## Technical product information

<b>Topic</b>	Rear door sunblind not retracting/opening fully
<b>Market area</b>	Bentley: worldwide (2WBE),Hongkong-Macau (5HK)
<b>Brand</b>	Bentley
<b>Transaction No.</b>	2052512/1
<b>Level</b>	EH
<b>Status</b>	Approval
<b>Release date</b>

Rear door sunblind not retracting/opening fully

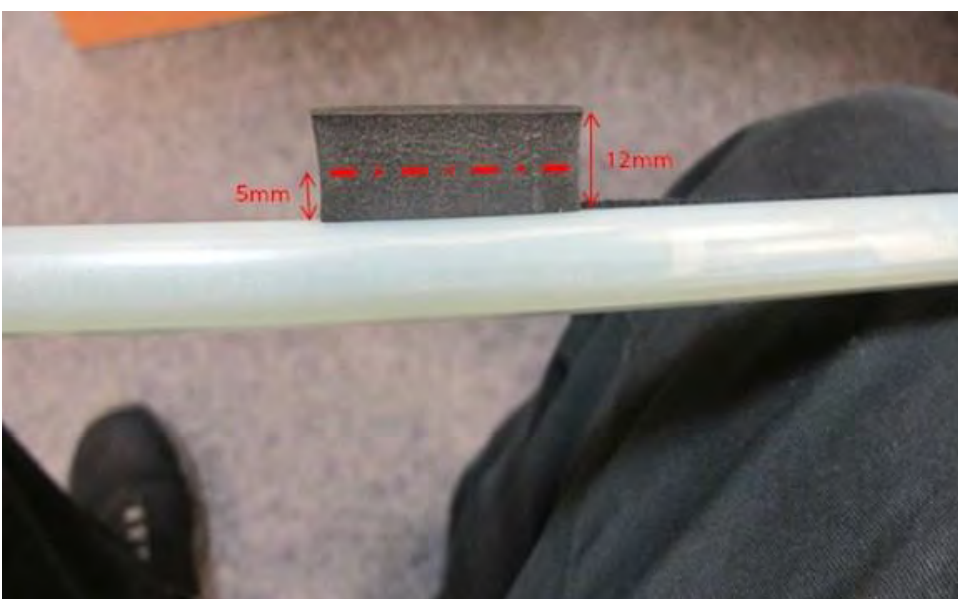
Under certain conditions the foam block on the sunblind motor can create excessive friction in the system, this can lead to difficulties in fully closing or fully opening the blind

Reduced thickness of the foam block on the blind rod from VINSJAAL14V4KC024036

1. Using a suitable cutting tool reduce the thickness of the foam block highlighted below from **12mm** to **5mm**

2. Remove the felt strips from the locations highlighted on the roller blind assembly
